Technical Service Bulletin: TSB250191

Fuel Injection Pump Bracket Countermeasure

- QST30 CM552

Figure 2, Example of P-clip mounting location

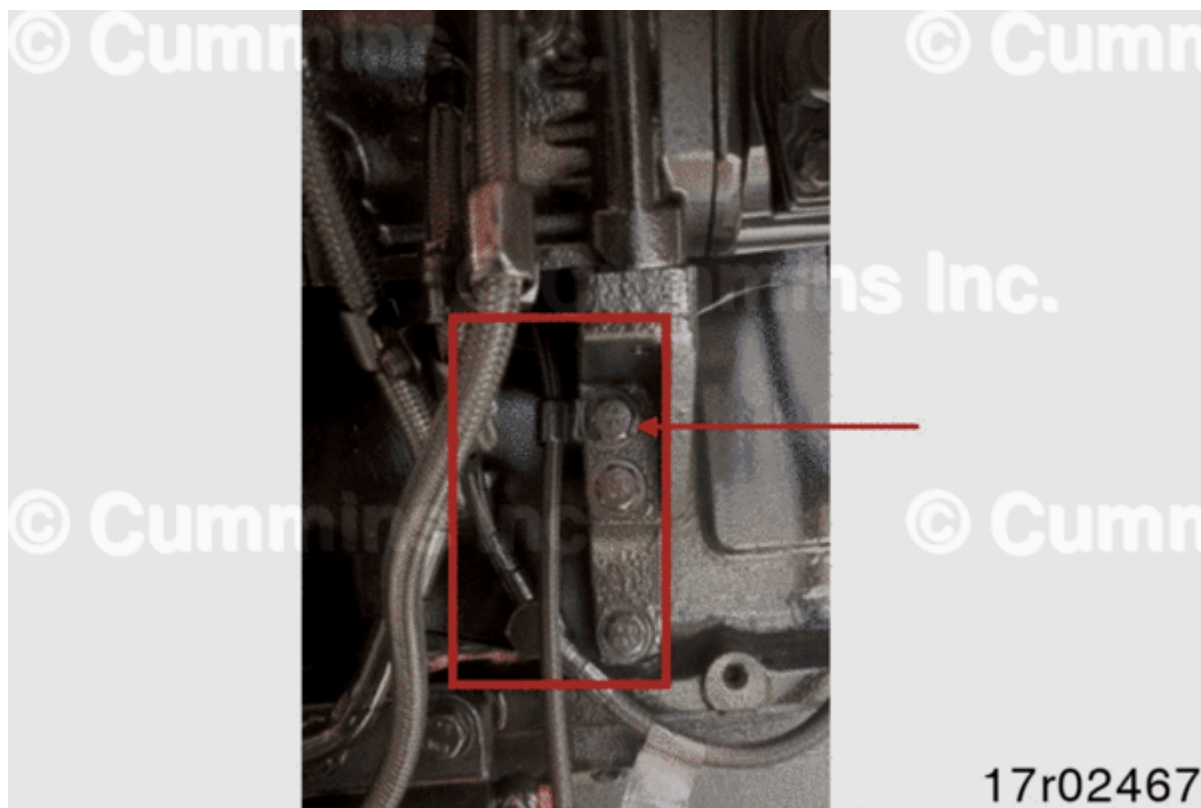
- The isolated spot-facing of the fuel injection mounting bracket creates a step that interferes with the P clip seating, leading to bending of the P-clip, progressive preload loss of the joint, capscrew loosening and possible fuel injection mounting bracket fracture.
 - In some instances, some fuel injection mounting brackets have been installed without the washer between the P clip and capscrew head included.

This issue pertains to any engine built with fuel injection mounting bracket Part Number 3093263 with a P-clip mounted in the location shown in Figure 2. This will be found on the left bank side of the engine.
